Staff Report for Item 2

Application Number: H15-01-1665

Address: #702 Pearl Street

Description of Work:

KEY WEST, FL. (305) 745-8611

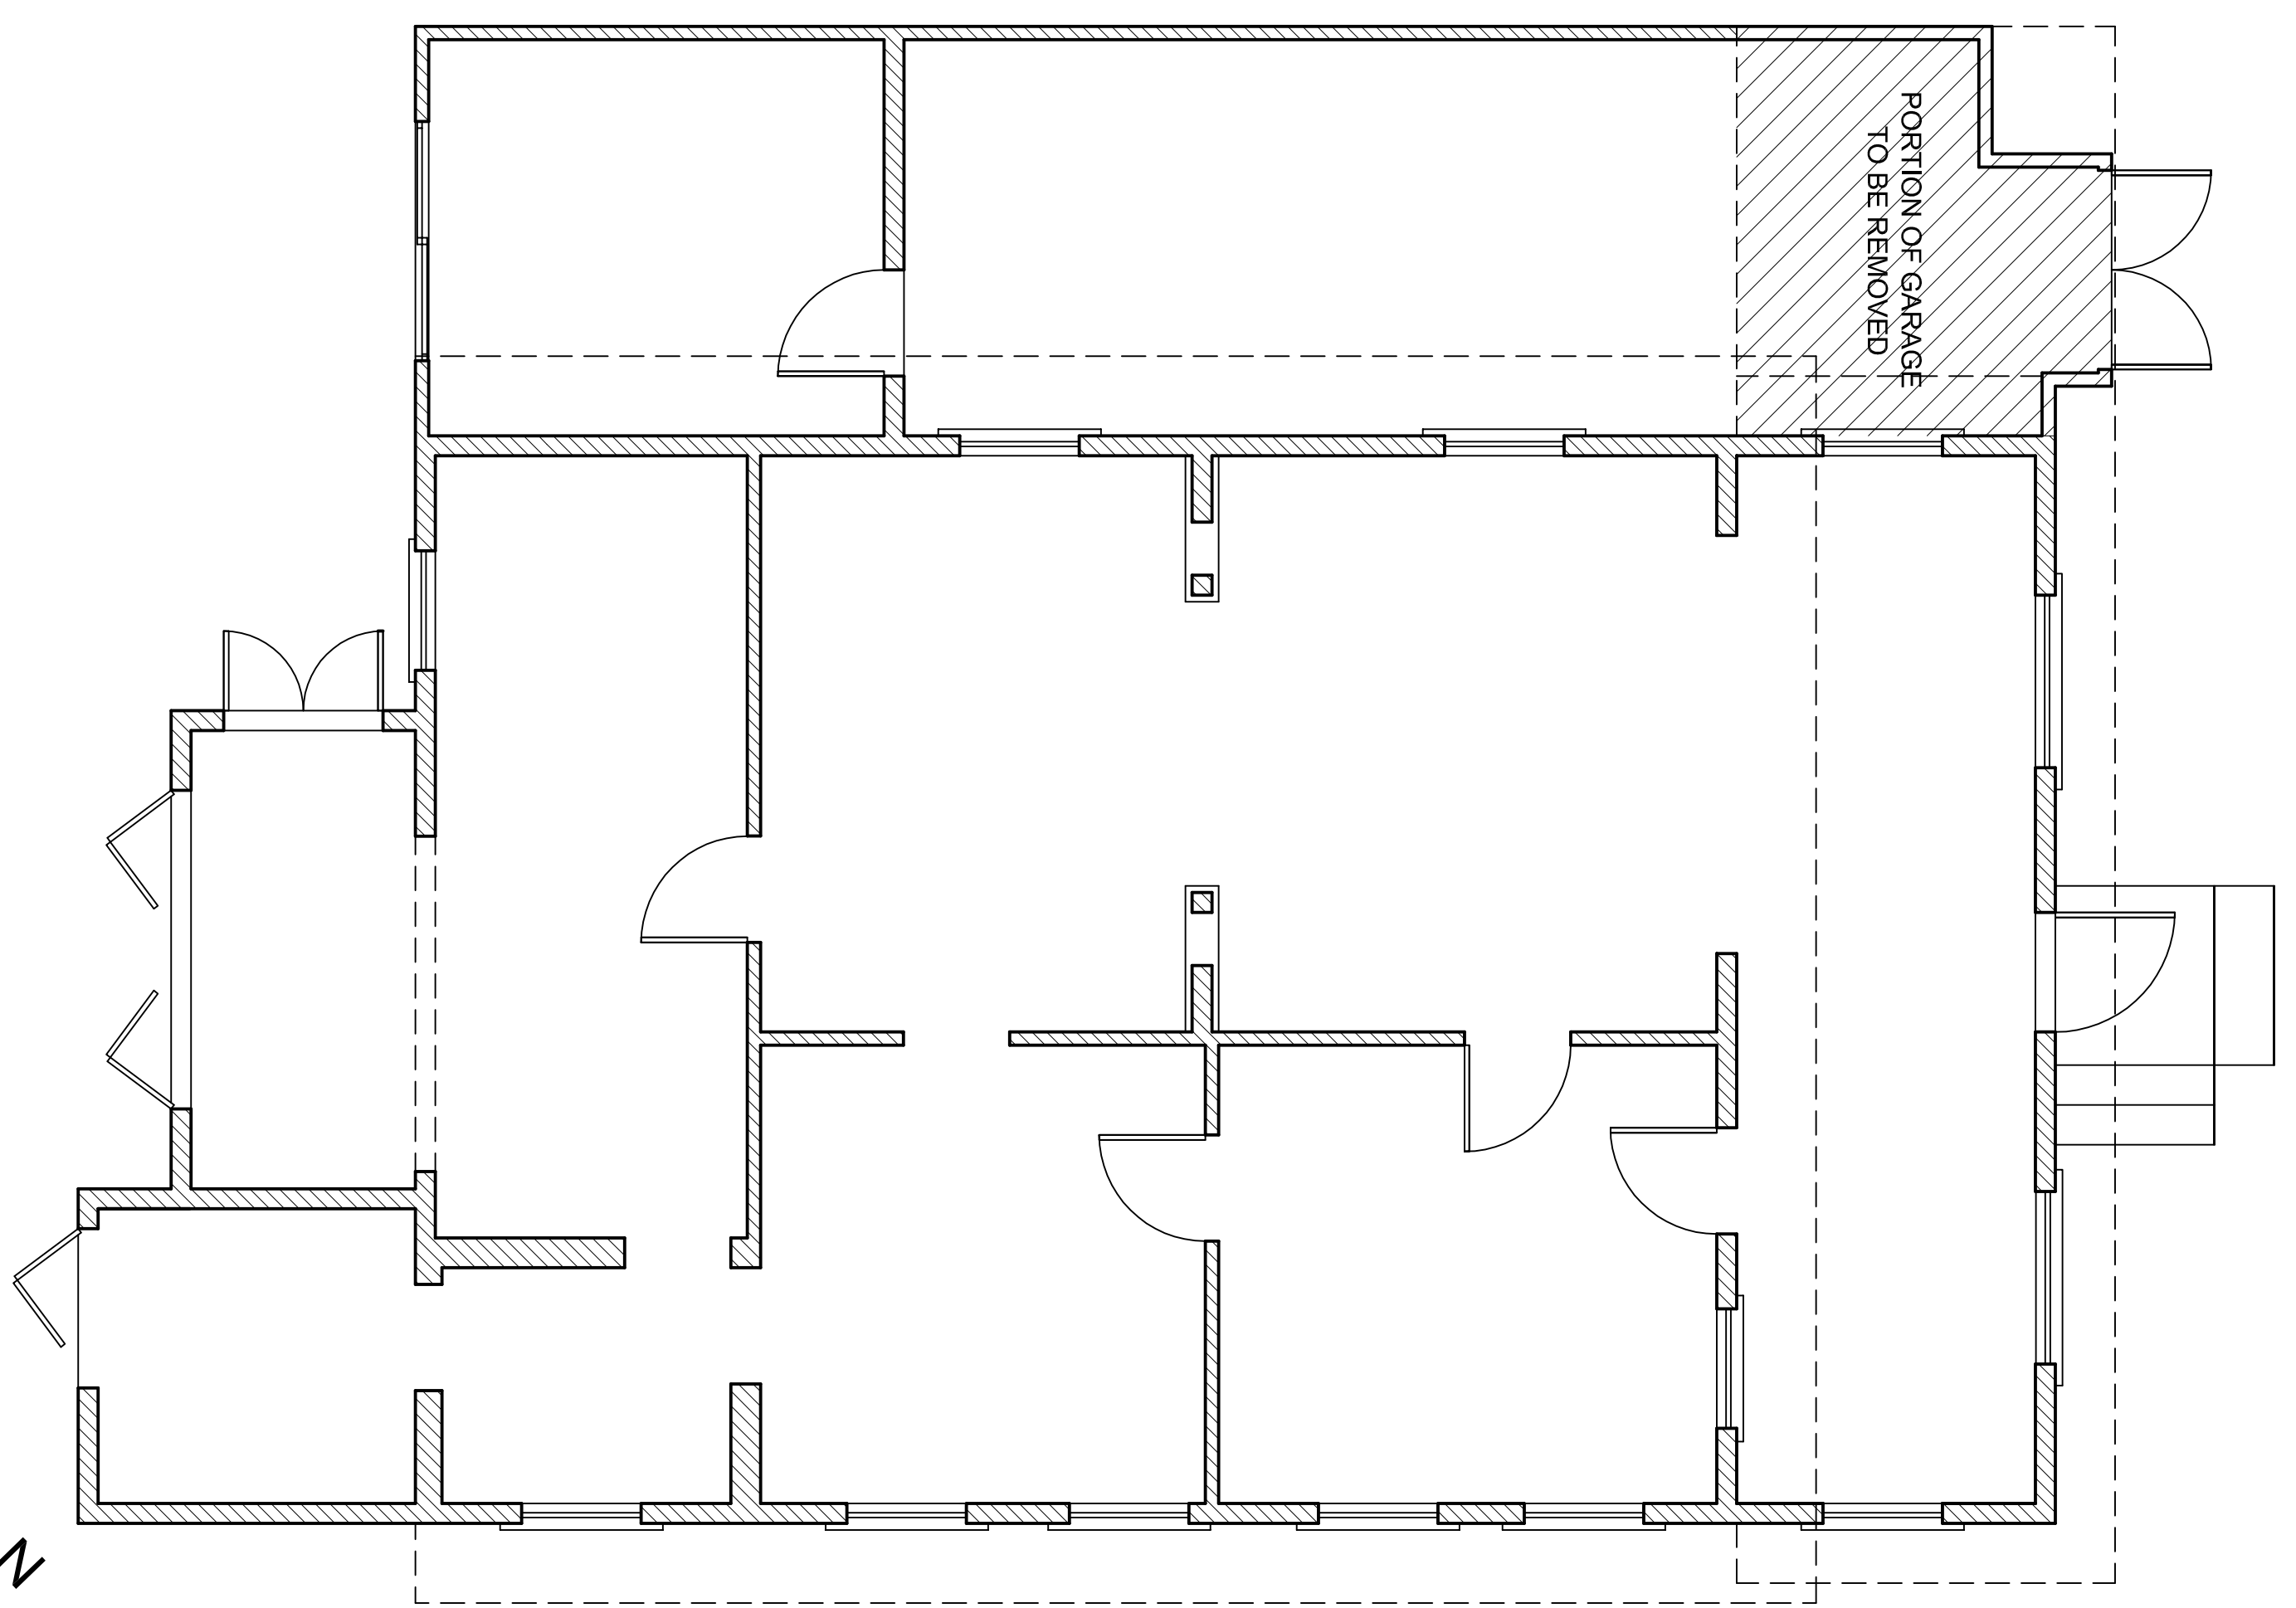
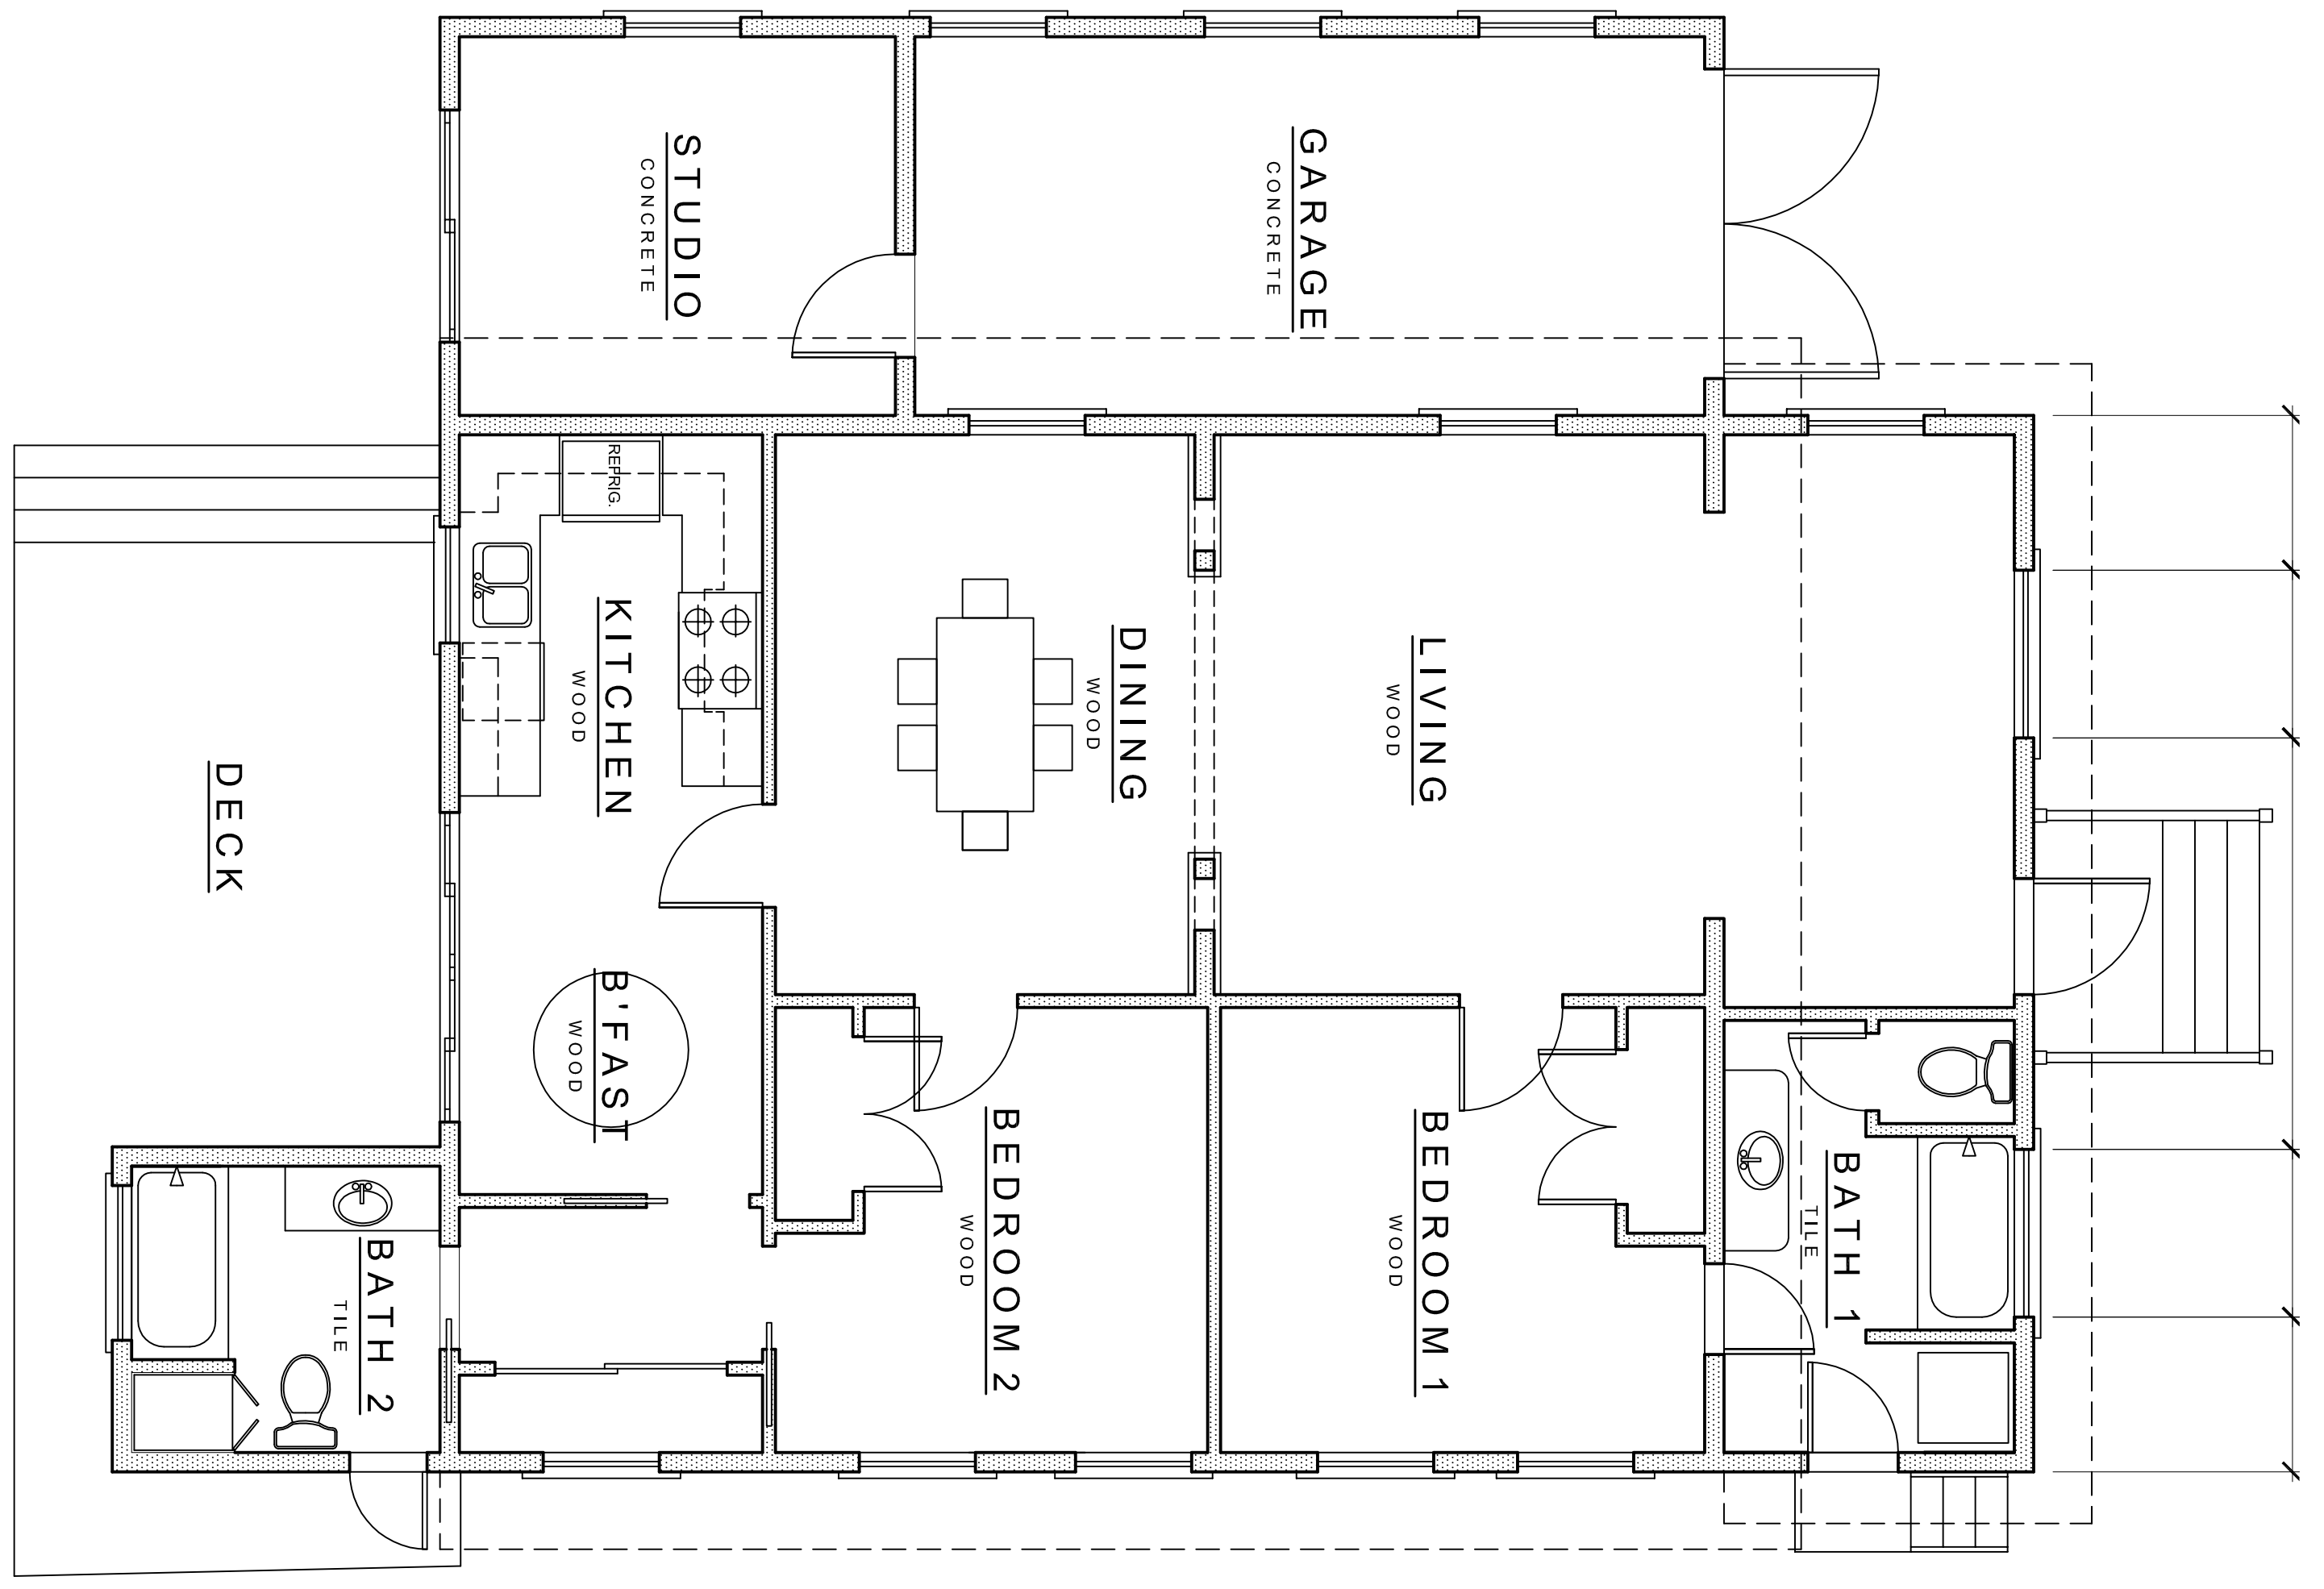
3. **A/C Unit:** The guidelines state that HVAC units should be sited in a location least visible from the public right-of-way whenever possible. It is possible to locate the mechanical equipment directly behind the garage in the rear yard. Mechanical equipment only need 5 feet setback, and there are many reasonable places to locate the equipment in the backyard.

When speaking with Kelly recently about your issue concerning the condenser location, I told her that I would speak with the owner about the matter. I have spoken with them and we thoroughly discussed all the options we were able to conceive of regarding alternate locations of this equipment to the current location on the rear of the garage roof as shown in my drawings.

Because the lot is substandard, the building drastically crowds the rear property line and leaves very little area for outdoor activities and foliage. That and the condition by Planning that such equipment cannot be any closer to the side and rear property lines than 5'-0" leaves no real desirable alternative. I would ask you to look closely at the drawings to verify these conditions.

Furthermore, I am convinced that the proposed location on the garage roof, well outside the side yard building setback line and at the extreme rear of garage would render the equipment not viewable from the street. A visit to the site would verify this. The height at the lowest end of the roof is 9'-6" and it slopes to higher at the house.

As mentioned in the staff report given the 5 foot setback requirement for AC units it is clear that an alternative location on the ground could be considered. If the re-design moves the railings out of the setback and the proposed second story is not in the required side yard setback, planning staff has no issues. Please coordinate with HARC staff moving forward.
